MODIFICATION #9
STREET 'C' MODIFIED SECTION

Request for a Modification to a Road Standard and/or to Project Conditions

Project Number: TM 5571/5572 Date of Request: April 4, 2013

Project Location: East side of Interstate 15, southerly of W. Lilac Road in the County of San Diego, State of California.

ATTACHMENT 1
WITH MODIFICATION #9
STREET 'C'

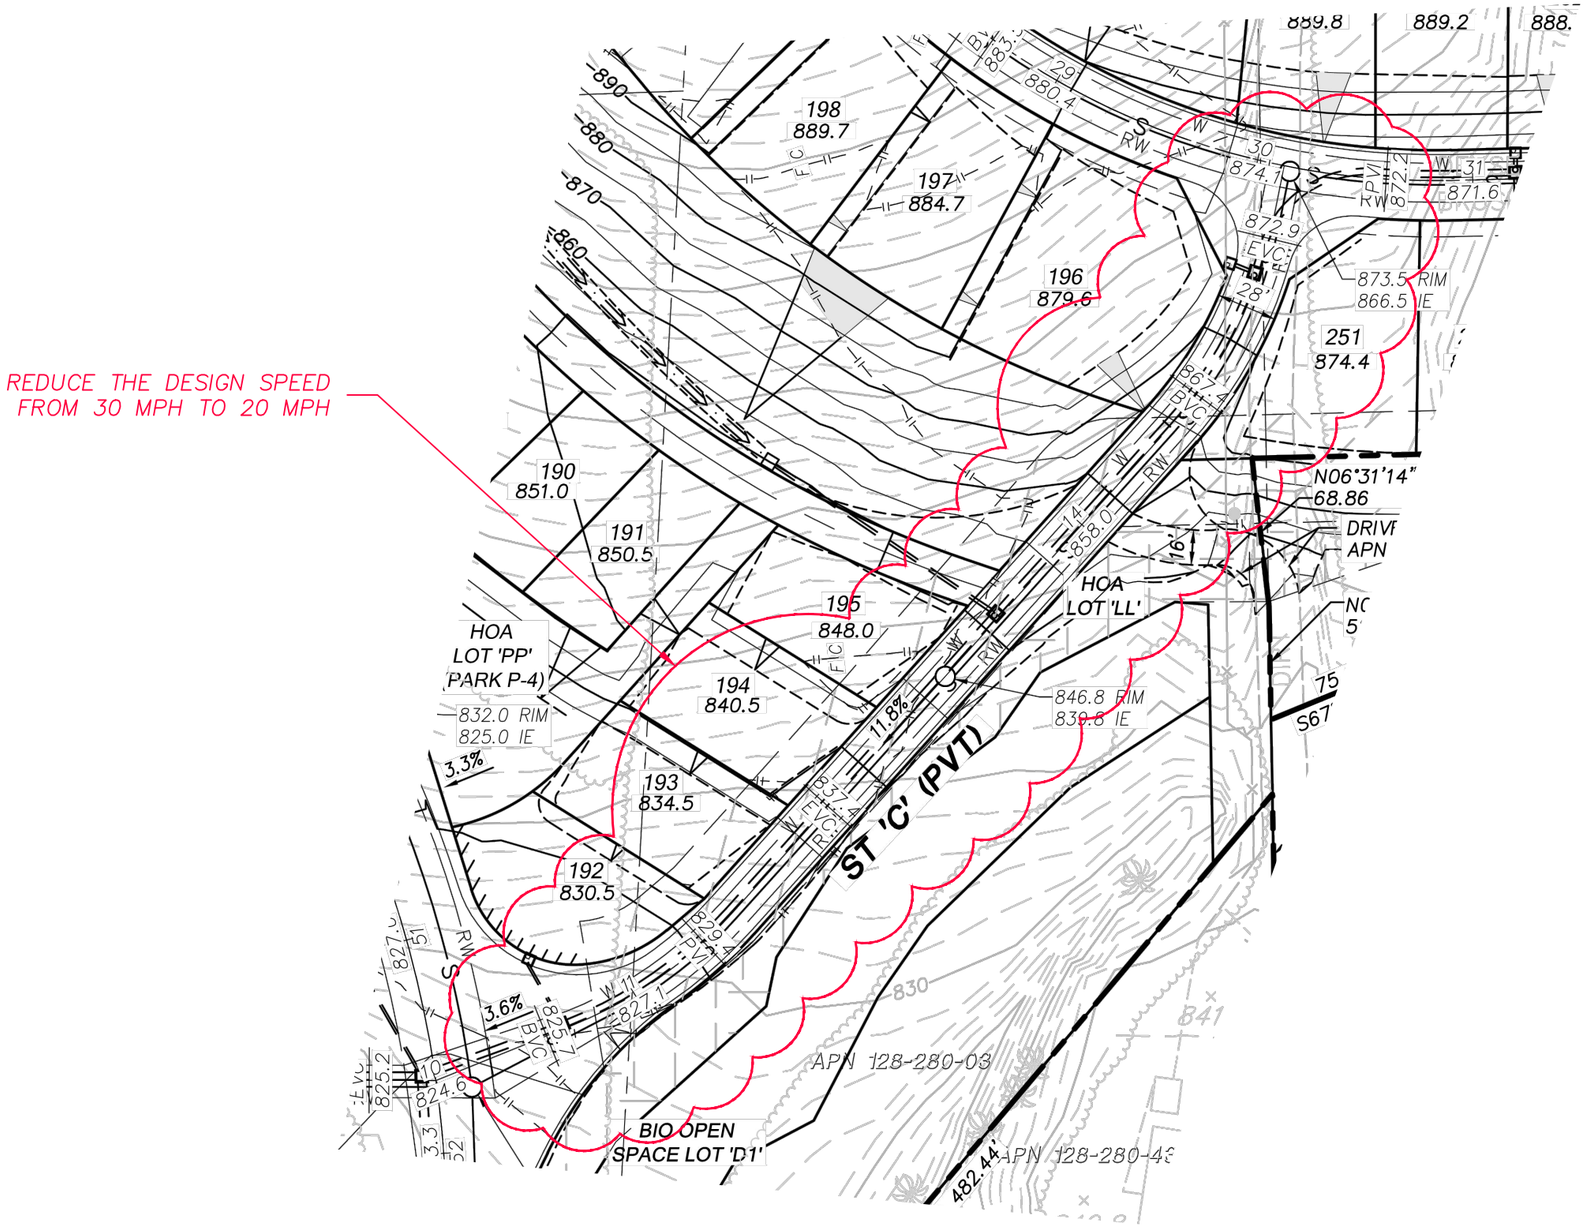
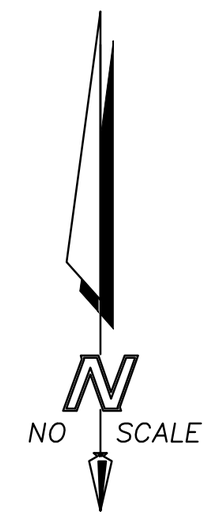
Requested Modification (attach engineering sketches showing existing layout, details and notes):
The standard road section for a Private Road is 24' paved width on 28' ROW with a minimum design speed of 30 mph. The requested modification to the road standard is to reduce the designed speed to 20 mph.

Reason for requested Modification (provide attachment if additional space is required):
Increasing the design speed on this 500' long road to 30 mph will require additional grading and impacts to adjacent Wetlands. A secondary impact is that the new alignment will alter the natural view planes along Street 'C'. Furthermore, this is a very short road segment and it is very unlikely & undesirable for a car to accelerate to 30 mph.

Describe the hardship(s) to the property owner(s) and/or neighbor(s) if the request is not approved (see note 3. on reverse): Increasing the design speed will require a new vertical curve design in a constrained distance (500') with manufactured slopes and wetlands on either side of road.
